UNITED STATES PATENT AND TRADEMARK OFFICE

APPLICATION NO.	FILING DATE	FIRST NAMED INVENTOR	ATTORNEY DOCKET NO.	CONFIRMATION NO.
10/781,177	02/18/2004	Rafail Zubok	SPINE 3.0-455 CIP CONT I	1815
530 7590 01/30/2007 LERNER, DAVID, LITTENBERG, KRUMHOLZ & MENTLIK 600 SOUTH AVENUE WEST WESTFIELD, NJ 07090			EXAMINER WOODALL, NICHOLAS W	
			ART UNIT 3733	PAPER NUMBER
SHORTENED STATUTORY PERIOD OF RESPONSE		MAIL DATE	DELIVERY MODE	
3 MONTHS		01/30/2007	PAPER

Office Action Summary

DETAILED ACTION

Figure 1

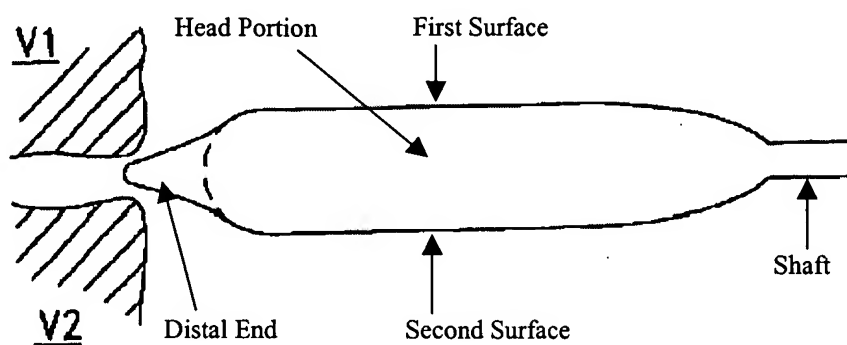
each device comprises a shaft having a handle at a proximal end and a head disposed at a distal end of the shaft. The head includes a first surface and a second surface that are spaced apart. Foley further discloses the set of devices have head portions that differ in size (column 18 lines 42-55). Regarding claims 11 and 12, Foley discloses a set of devices wherein the heads of the devices differ in thickness by about 1 mm (column 7 lines 3-7). Regarding claim, Foley discloses a set of devices wherein a square area of the head portions is different between the devices. Since Foley discloses a set of devices that have different thickness the devices also have a square area that is different. Regarding claim 15, Foley discloses a set of device further including one or more disc replacement devices (column 18 lines 42-55). Regarding claim 16, Foley discloses a method of using a device as discussed above comprising the steps of inserting a first trial into one of the intervertebral disc spaces to facilitate at least some distraction of the vertebral bones in a direction along a longitudinal axis and inserting a second trial into the intervertebral disc space to facilitate at least some further distraction of the vertebral bones along the longitudinal axis, where the second trial has a larger head thickness, measured substantially from the first surface to the second surface, than that of the first trial (column 19 lines 22-33). Regarding claims 17-20, Foley discloses a device that can be inherently used by a method as discussed above further including the steps of levering the handle of at least one of the first and second trials to facilitate the distraction of the vertebral bones (claim 17), repeating the insertion of further trials having a larger and larger head thickness to facilitate the distraction of the vertebral bones to a target distance (claim 18), wherein the target distance is one

that substantially maximizes the intervertebral space while substantially preserving an annulus and ligaments associated with the vertebral bones (claim 19), and inserting an intervertebral disc replacement device into the intervertebral space after it has been distracted to the target distance.
